**Re: State of New Mexico Environment Department-Springer Building
(Resubmittal)
121 Tijeras Ave. NE
Traffic Circulation Layout
Engineer's/Architect's Stamp dated 7-2-15 (K14-D036)**

**Re: State of New Mexico Environment Department-Springer Building
121 Tijeras Ave. NE
Traffic Circulation Layout
Engineer's/Architect's Stamp dated 6-23-15 (K14-D036)**

**Re: State of New Mexico Environment Department-Springer Building
121 Tijeras Ave. NE
Traffic Circulation Layout
Engineer's/Architect's Stamp dated 4-20-15 (K14-D036)**

Based upon the information provided in your submittal received 5-12-15, the above referenced plan cannot be approved for Building Permit until the following comments are addressed:

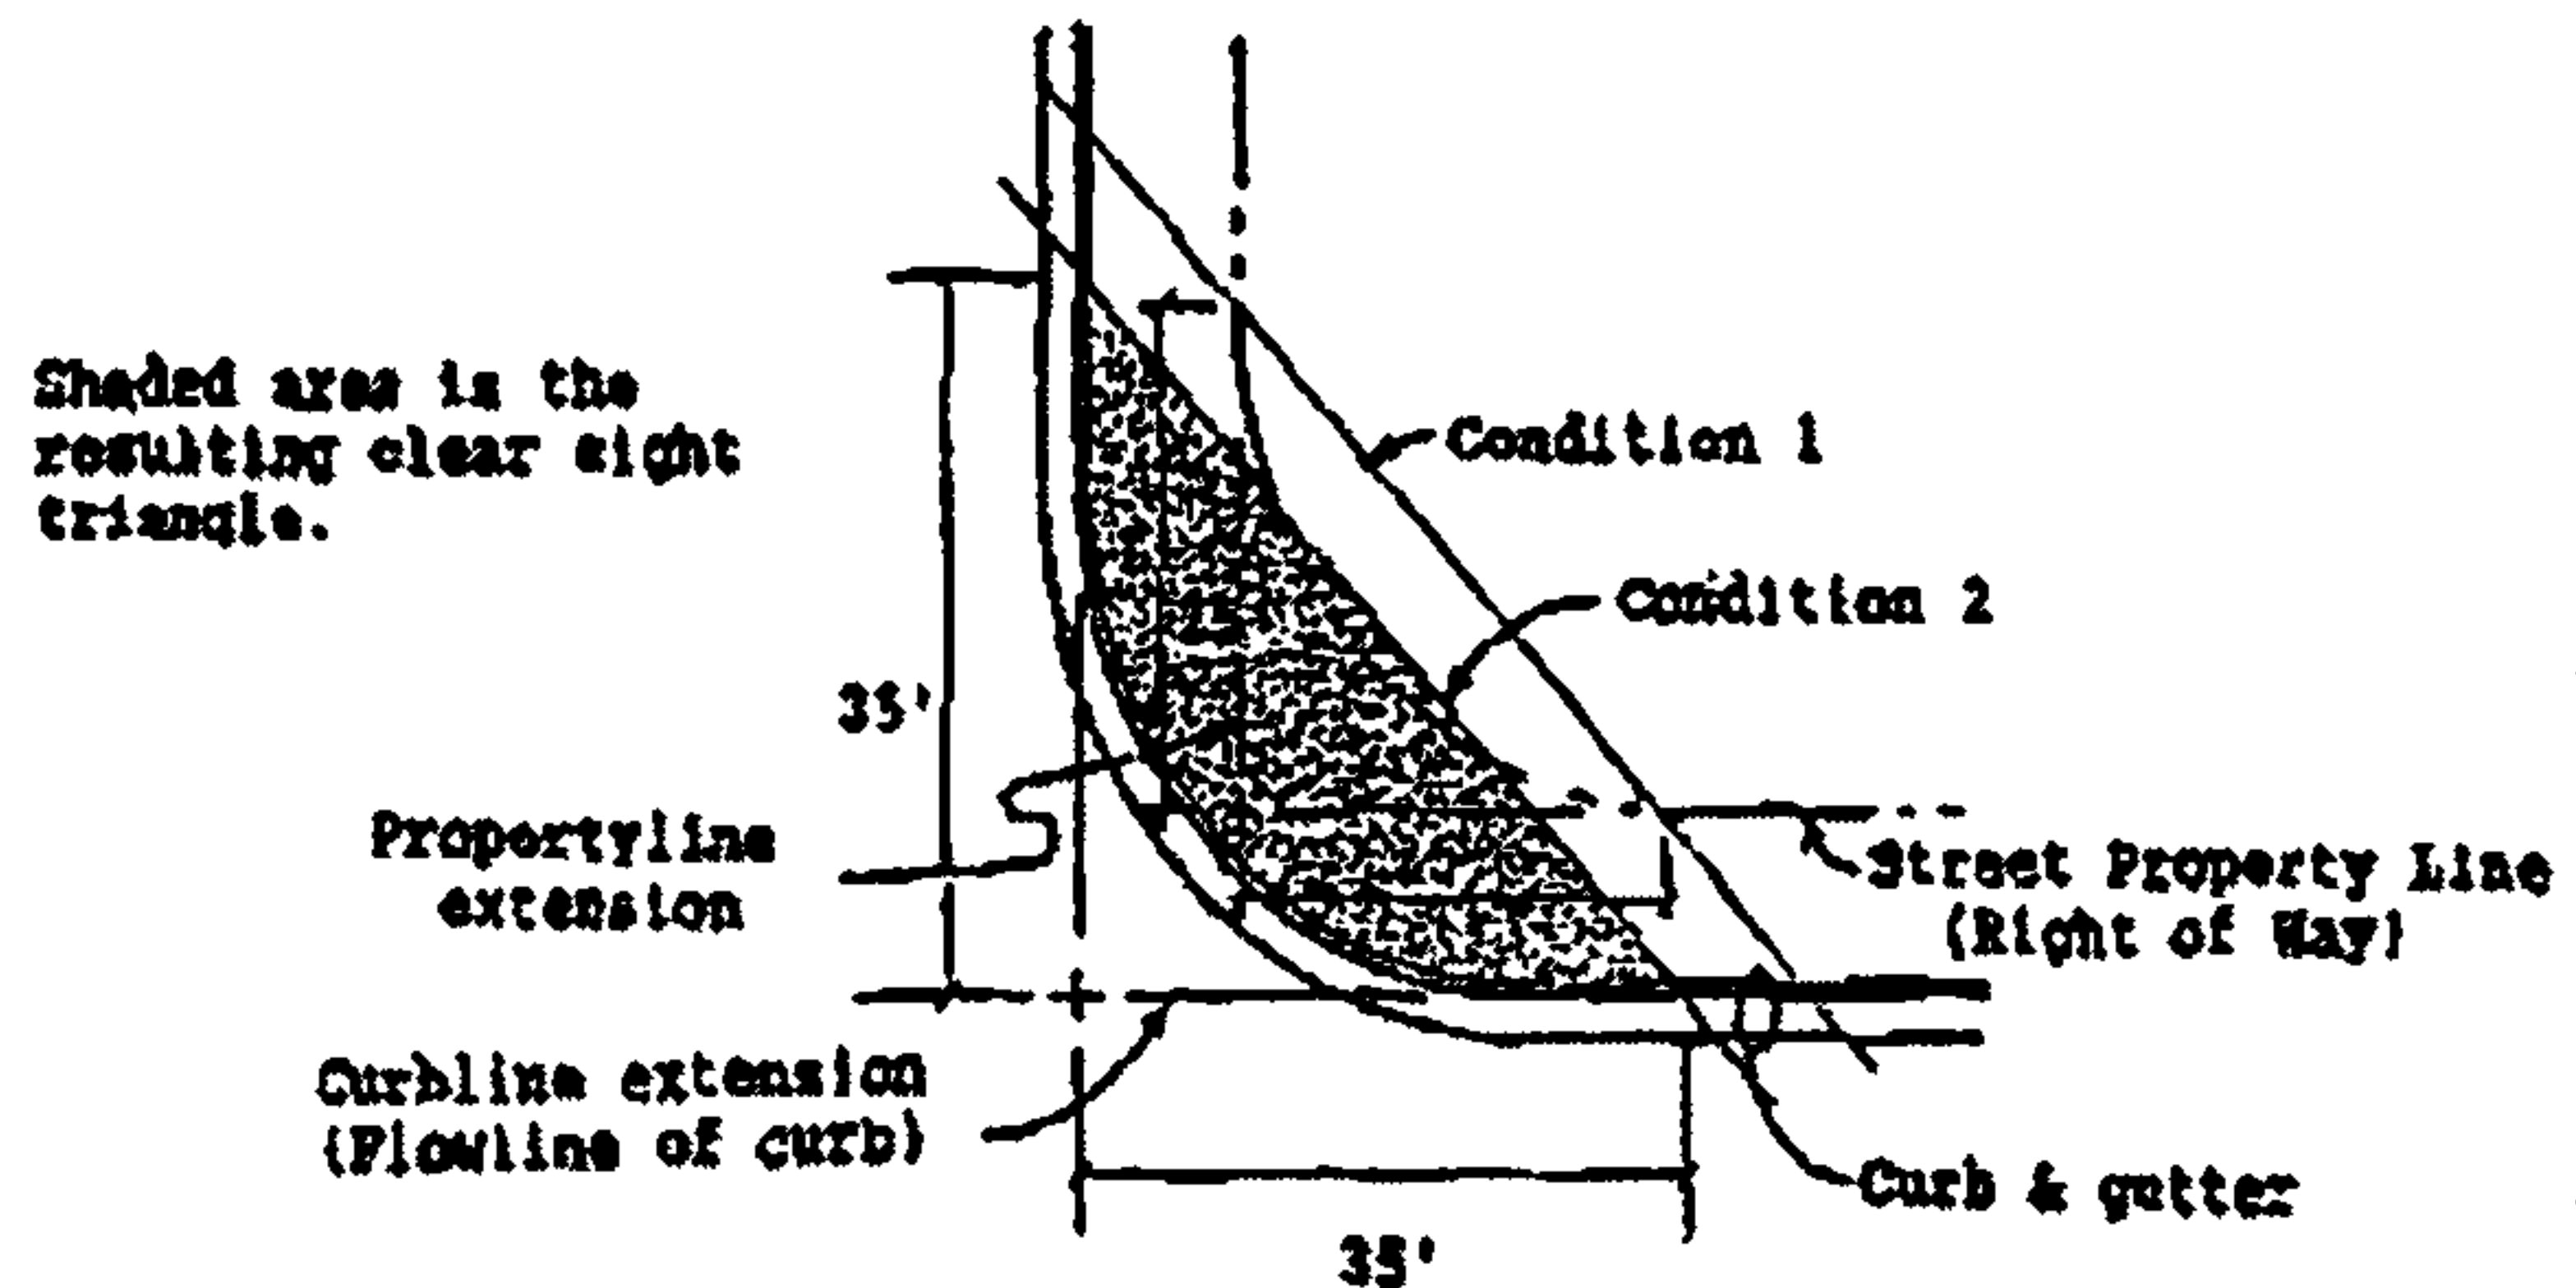
1. Please show a vicinity map showing the location of the development in relation to streets and well known landmarks.
2. Label new lot as "Overflow Parking".

3. Clarify the extents of the current phase. Please label existing buildings.
4. Please clarify the use of temporary parking. Is it be used just during construction?

5. Please identify all existing buildings, doors, structures, sidewalks, curbs, drive pads, walls and anything that influences the parking and circulation on the site.

6. Identify all existing access easements and rights of way with dimensions.
7. Identify the right of way width, medians, curb cuts, and street widths on Tijeras Ave., Dr. Martin Luther King Jr.Ave., and Commercial St.

8. The lot must be graded and surfaced with blacktop or equal: Two inches of asphalt concrete on a prime coat over a four inch compacted subgrade, or a surface of equal or superior performance characteristics. If street curbs and gutters exist adjacent to the parking lot property on a side where lot egress is allowed, the surfacing shall be blacktop for the width of the egress drive(s) and shall extend inward from the property line a minimum of 25 feet along all normal lines of egress traffic flow from the lot. All paving shall be maintained level and serviceable (i.e. no potholes). The City Engineer will have to approve a grading and drainage plan before the asphalt can be installed.

9. For parking lots of 20 or fewer spaces: A layer at least two inches thick of gravel sized from 3/8 minimum to one inch maximum diameter, at least ½ inch of which shall be maintained on the surface; gravel shall be kept off the right-of-way.

10. A parking lot shall include landscaping planted and maintained according to a Landscaping Plan approved by the Planning Director; however, the Planning Commission may waive this requirement where it is found not useful to achieving the intent of this Zoning Code.

11. The lot shall have barriers which prevent vehicles from extending over the sidewalk or abutting lots, or beyond the sides of a parking structure. The plans do already address providing concrete vehicular wheel stops.

12. Please list the width and length for all existing and proposed parking spaces. Please clearly detail how each parking space is to be marked and if there will be curb stop or car parking bumpers installed in each parking space. The minimum parking space width is 8.5 ft.

13. The ADA van accessible sign must have the required language per 66-7-352.4C NMSA 1978 **"Violators Are Subject to a Fine and/or Towing."** Please show a detail of the existing ADA signs.

14. The ADA access aisle shall have the words **"NO PARKING"** in capital letters, each of which shall be at least one foot high and at least two inches wide, placed at the rear of the parking space so as to be close to where an adjacent vehicle's rear tire would be placed. (66-1-4.1.B NMSA 1978)

15. Show all drive aisle widths and radii.
16. List radii for all curves shown; for passenger vehicles, the minimum end island radius is 15 feet. Landscape island radius for delivery trucks, fire trucks, etc. is 25 feet or larger

17. Per the DPM, a 6 ft. wide ADA accessible pedestrian pathway is required from the public sidewalk to the building entrances. Please clearly show this pathway and provide details from the proposed temporary parking.

18. Per the DPM, a 6 ft. wide ADA accessible pedestrian pathway is required from the HC parking stall access aisles to the building entrances. Please clearly show the ADA pedestrian pathway from the existing and proposed parking to the building entrance.

19. Provide a min 6" or max 8" high concrete barrier curb or other acceptable barrier between landscaping and parking areas and/or drive aisles.
20. Please provide a sight distance exhibit for entrance off of Broadway Blvd. (see the *Development Process Manual, Chapter 23, Section 3, Part D.5 Intersection Sight Distance*).

21. Please add the following note to the clear sight triangle: "Landscaping and signage will not interfere with clear sight requirements. Therefore, signs, walls, trees, and shrubbery between 3 and 8 feet tall (as measured from the gutter pan) will not be acceptable in this area."
22. Please specify the City Standard Drawing Number when applicable.
23. Work within the public right of way requires a work order with DRC approved plans.
24. See Chapter 23, Section 6 of the City of Albuquerque *Development Process Manual*, for appropriate drive pad widths.
25. Please include two copies of the traffic circulation layout at the next submittal.
